ADDENDUM NO. 2

PROJECT TITLE: Parker Park Community Center Pool Addition
City of Jonesboro
Jonesboro, Arkansas

COMMISSION NUMBER: 2301

DATE OF ISSUE: August 21, 2023

C003

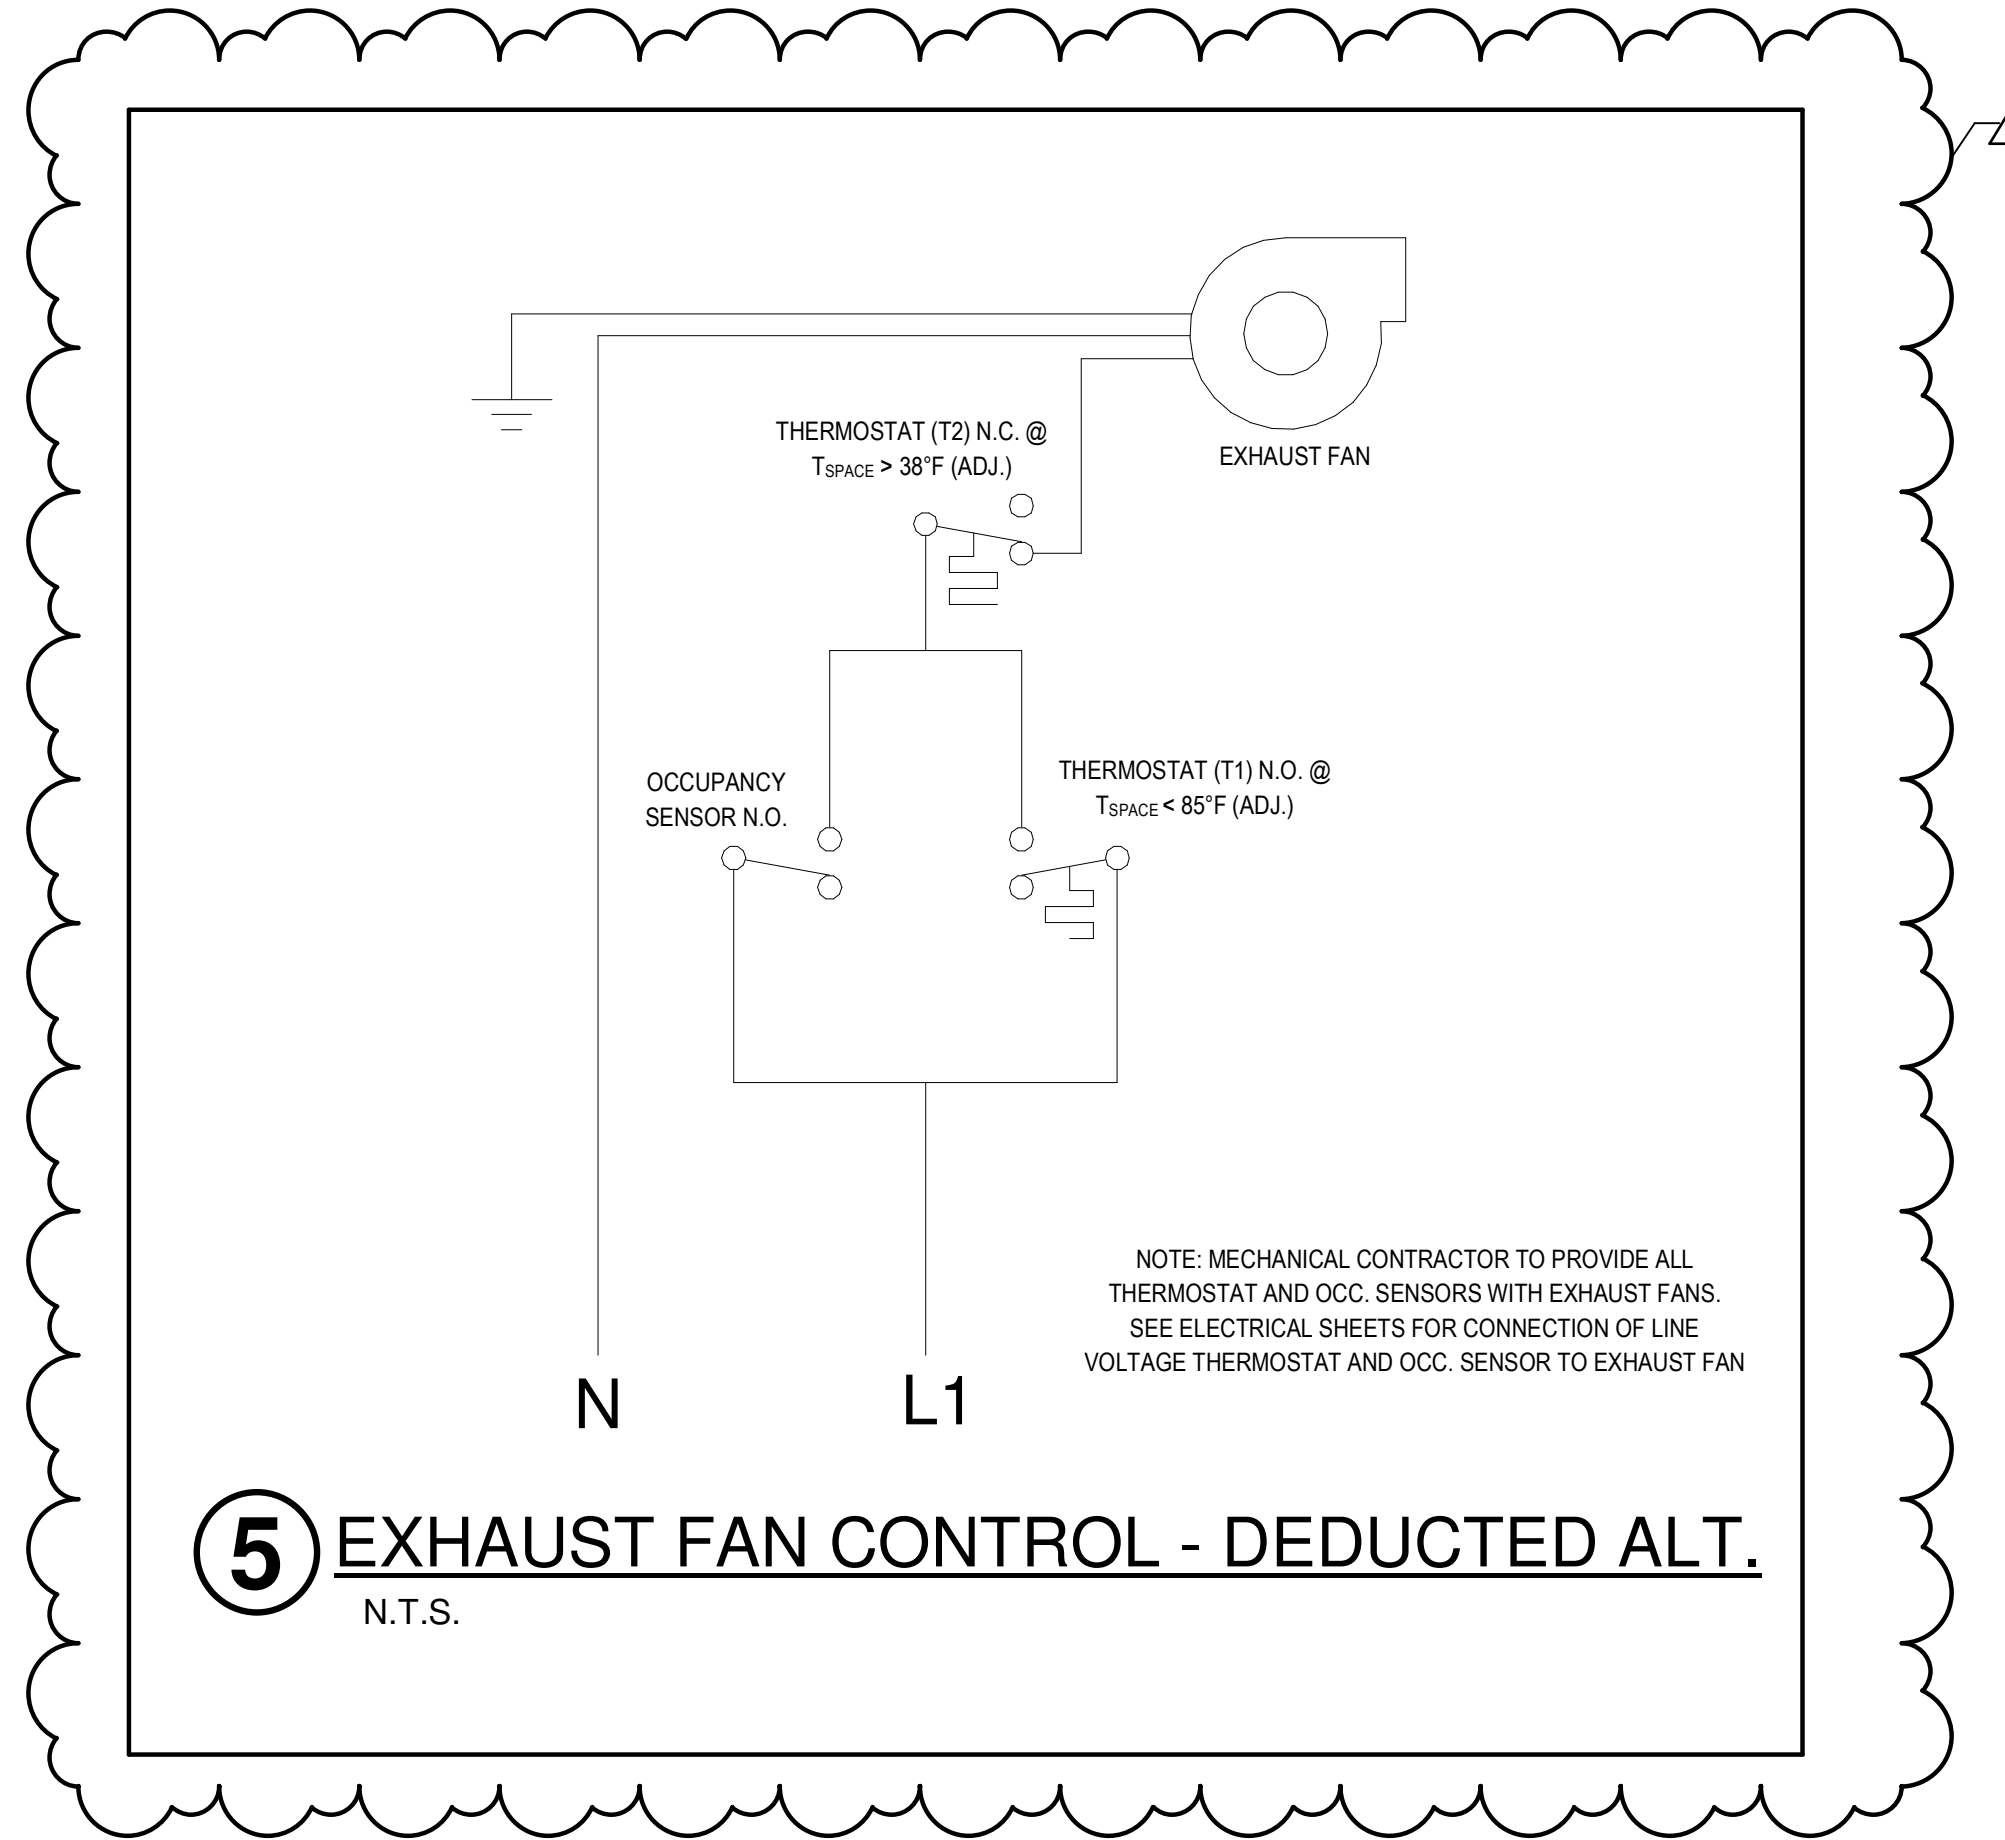
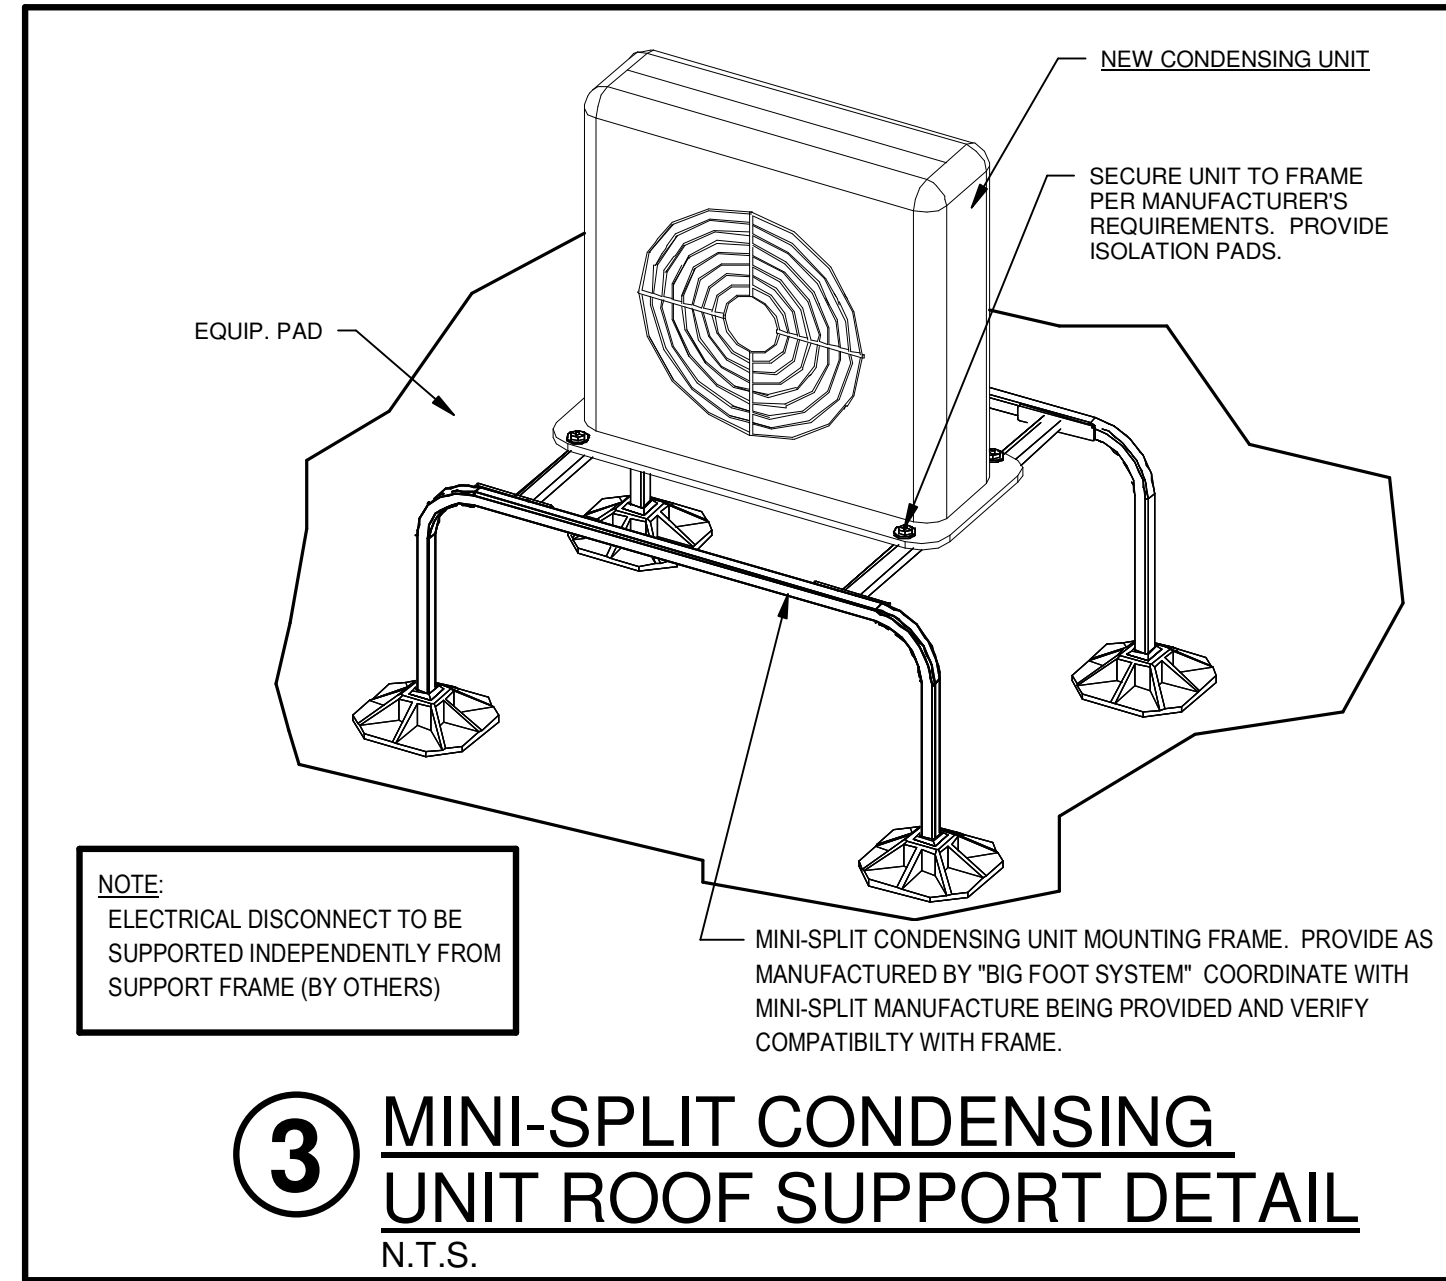
2. Drawings: Sheet C003- Enlarged Site Plan

- A. Omit Sheet C003 in its entirety. Replace with attached Sheet C003 dated 08.21.23. Refer to page 6 of this addendum.
- a. Provide self-closing (tension-adjustable) closers on all 4’-0” wide single walk gates. Design intent is for these gates to close and positively latch when entering or exiting.
 - b. Provide expanded metal covers for surge tank, pump, backwash and acid storage pits as indicated by detail 1. This will require (4) covers total matching the interior dimensions of these (4) pits. Provide min. 2 hinged access doors. All steel and expanded metal are to be galvanized.
 - c. Provide (4) additional umbrellas on patio in addition to umbrella located in the pool. See Q/A section for specifications of umbrellas and sheet C
